MODERNIZATION AT
 CURRAN MIDDLE
 SCHOOL
 FOR:

BAKERSFIELD
 CITY SCHOOL
 DISTRICT
 1116 LYRIC WAY
 BAKERSFIELD
 CALIFORNIA
 93309

MARK	DATE	DESCRIPTION
SD		
CD		
△	10/29/07	ADDENDUM #3
▽		
▽

ROOF FRAMING PLAN
 BUILDING 'F', 'G', & 'H'

ROOF FRAMING PLAN BUILDING 'F', 'G', & 'H'
 1/8" = 1'-0"

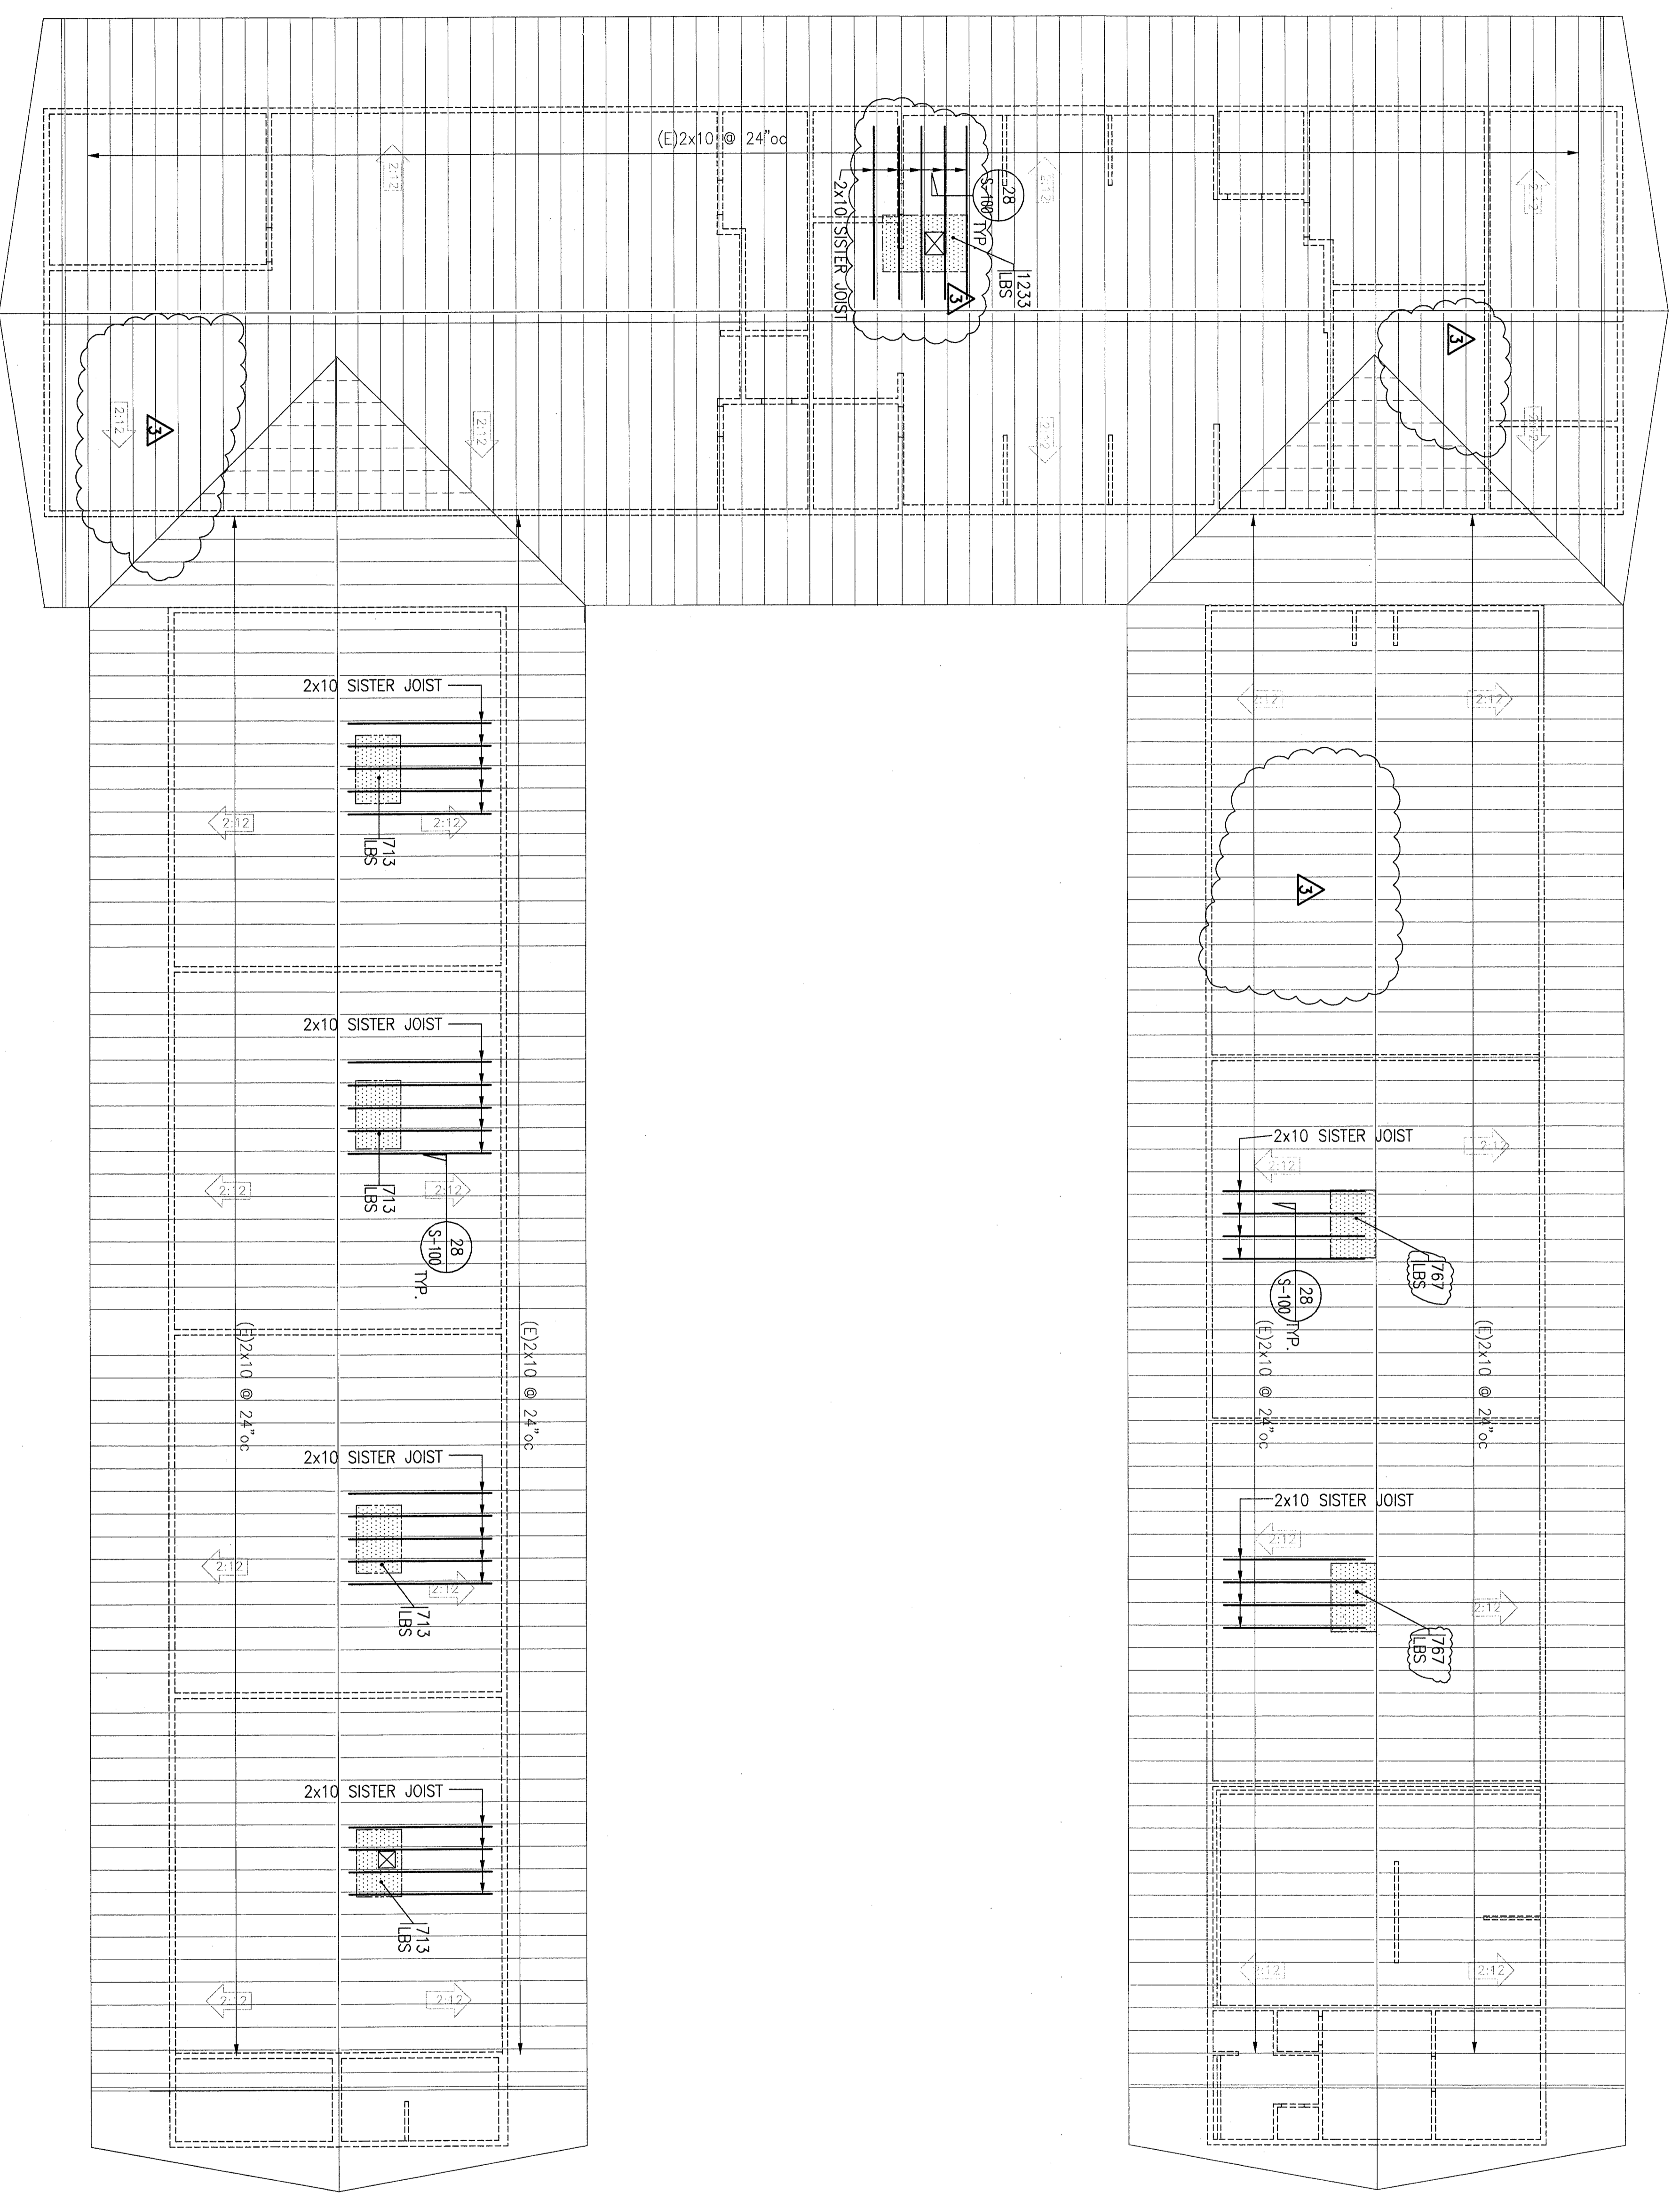
Item No. 6: Refer to Sheet S-204
 Item No. 3: Revise roof framing on Building 'F', 'G', & 'H' as shown on Sheet AS-203 in order to reflect revised HVAC unit location requirements per owner's request.
